APPLICATION FOR AMENDMENT

LICENSE NO. NPF-3

DAVIS-BESSE NUCLEAR POWER STATION

REQUESTED CHANGE TO
THE DAVIS-BESSE NUCLEAR POWER STATION
UNIT NO. 1
TECHNICAL SPECIFICATIONS
(Appendix A to License No. NPF-3)

Figure 2.1-2 Reactor Core Safety Limit

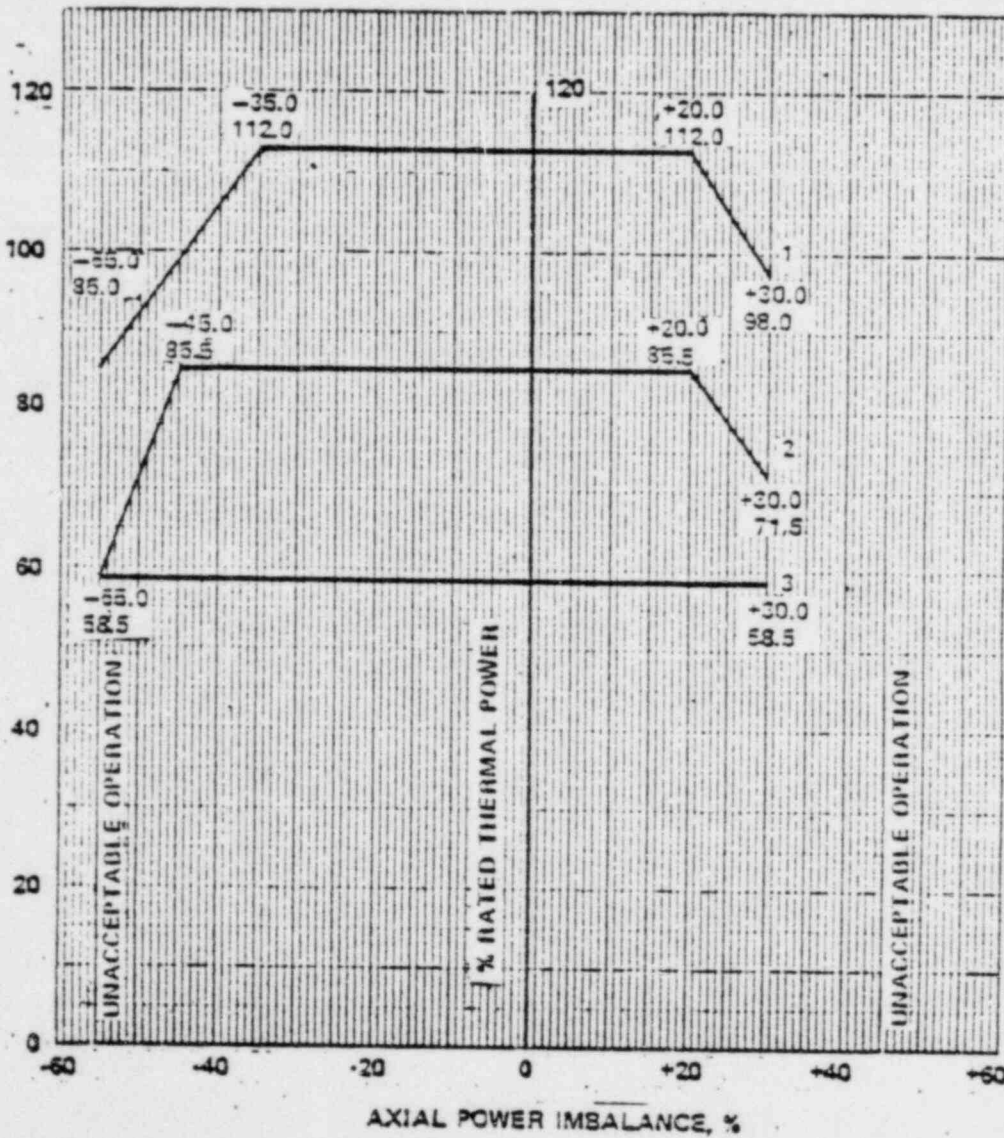
CURVE	REACTOR COOLANT FLOW (GPM)
1	387,200
2	290,100
3	191,000

Figure 2.2-1 Trip Setpoint for Flux- Δ Flux-Flow

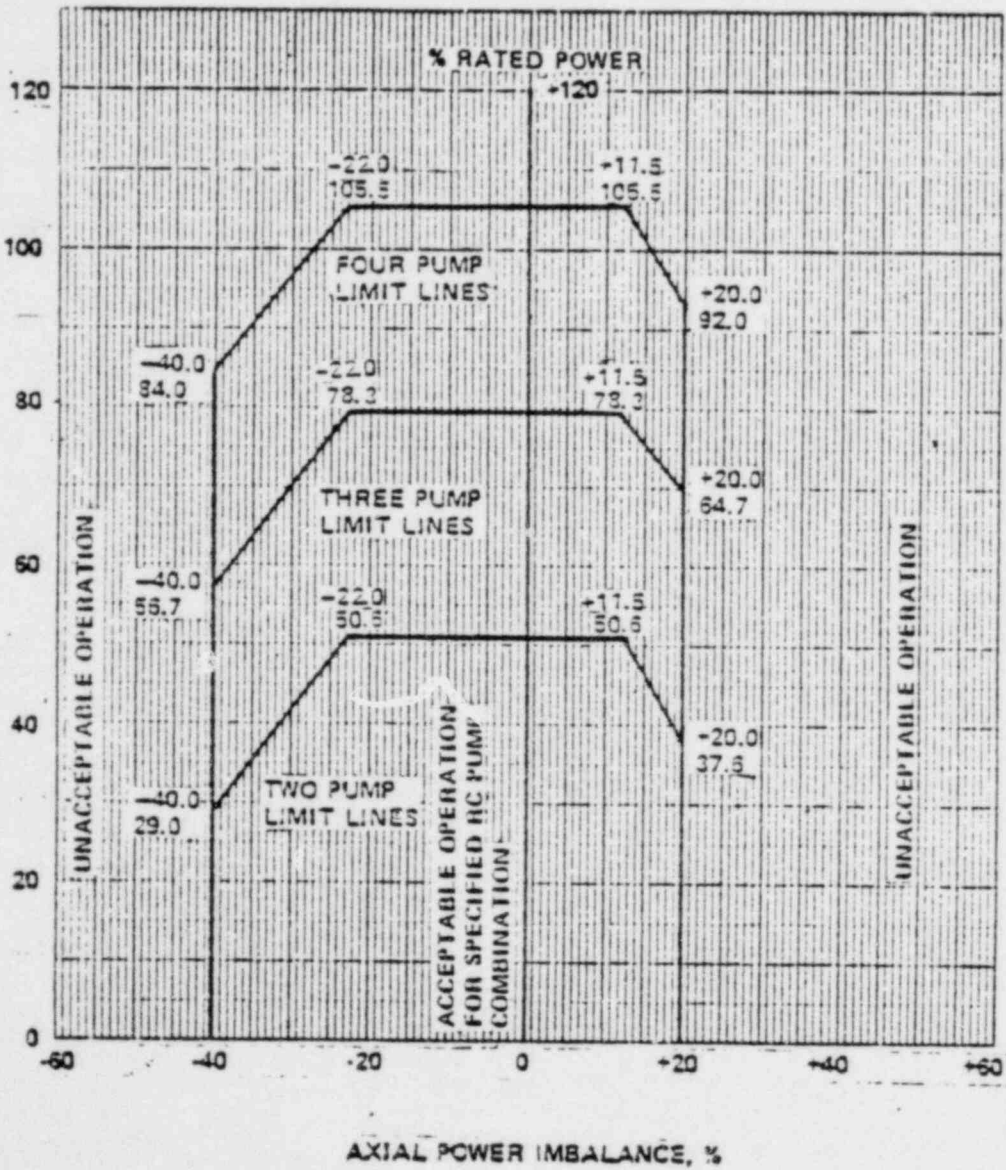
3. RC High Temperature	< 619°F	< 619.08°F#
4. Flux - Δ Flux-Flow(1)	Trip Setpoint not to exceed the Limit Line of Figure 2.2-1.	Allowable Values not to exceed the limit line of Figure 2.2-2.
